REMARKS/ARGUMENTS

[57] Abstract

Fig. 1

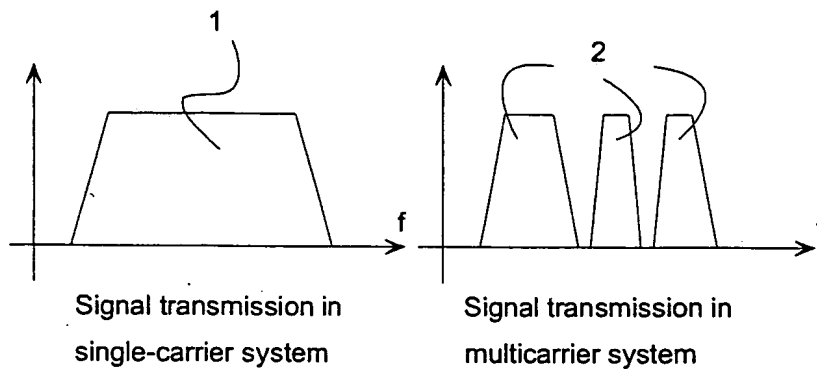
The Examiner has objected to Figs. 1-4 because they should be designated by a legend, which indicates only that which is old is illustrated. Applicants respectfully submit that corrected drawings are attached hereto, in which the label "CONVENTIONAL ART" has been added. Accordingly, Applicants respectfully request the Examiner to withdraw this objection.

CONVENTIONAL ART
